BEFORE THE PUBLIC SERVICE COMMISSION OF UTAH

In the Matter of the Application	:	DOCKET NO. 03-035-14
of PacifiCorp for an Order	:	PREFILED DIRECT TESTIMONY OF
Approving Avoided Cost Rates	:	PHILIP HAYET
	:	FOR THE COMMITTEE OF
	:	CONSUMER SERVICES

DIRECT TESTIMONY OF PHILIP M. HAYET

Figure 1

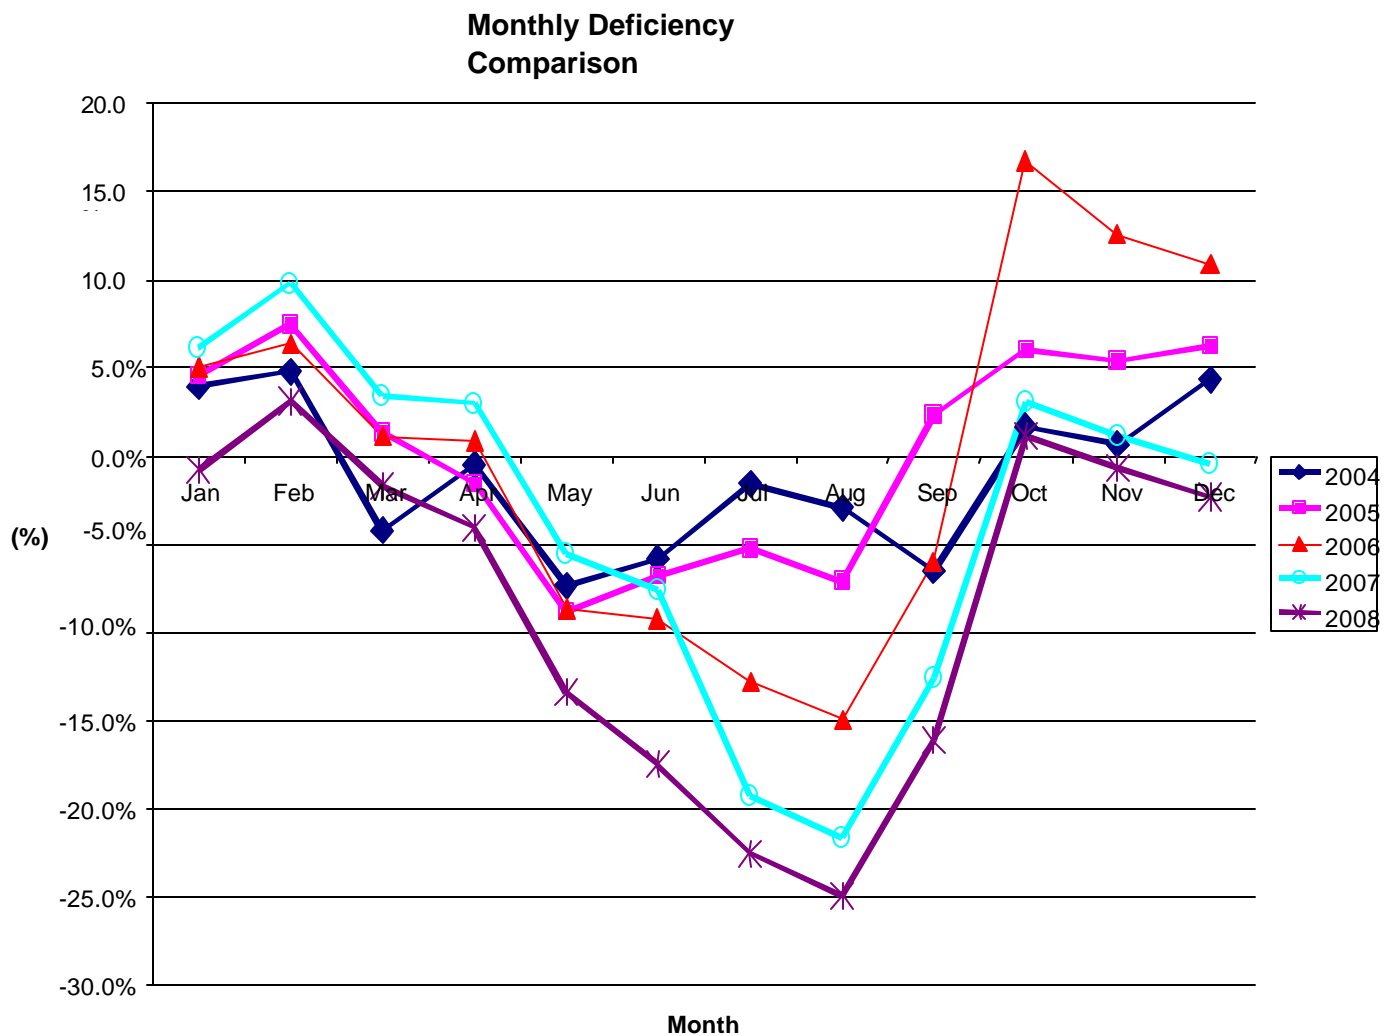
8 A. At a minimum, the Committee recommends that an avoided cost capacity payment be
9 made for six months out of twelve months for each year during the sufficiency period.
10 Figure 1 below shows PacifiCorp's resource sufficiency/deficiency for each month over
11 the 2004-2008 period. A negative value indicates that the Company receives
12 additional capacity resources and that QFs should receive avoided cost capacity
13 payments in these months. Figure 1 clearly demonstrates that during the 2004-2008
14 period PacifiCorp's annual deficiency is not just limited to the three summer months,
15 but on average a deficiency exists for six months.
